UNITED STATES PATENT AND TRADEMARK OFFICE

APPLICATION NO.	FILING DATE	FIRST NAMED INVENTOR	ATTORNEY DOCKET NO.	CONFIRMATION NO.
09/784,827	02/15/2001	Colm J. Prendergast	AD-217J	5800

Office Action Summary

DETAILED ACTION

FIG. 5

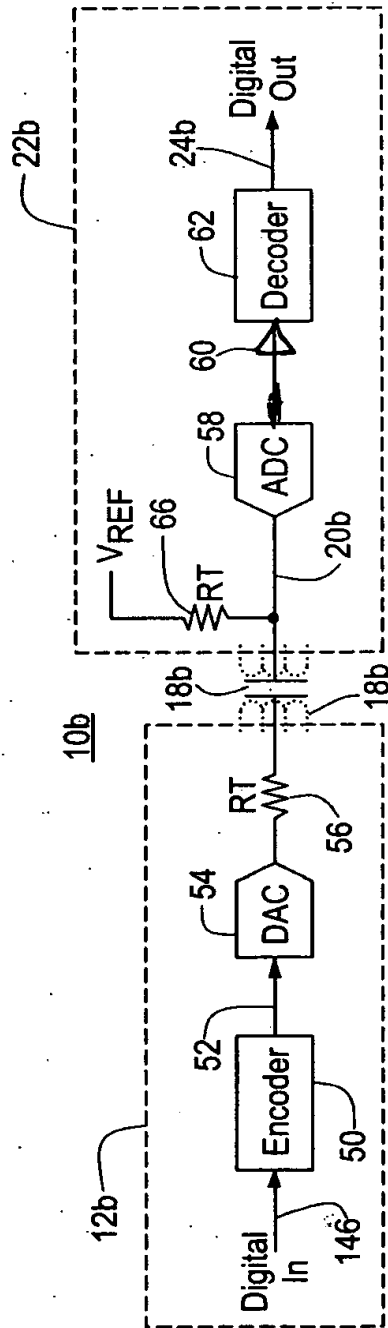
2. In Fig. 5, the direction of element 60 should be **reversed**. A marked-up copy of the drawing in red ink is enclosed.
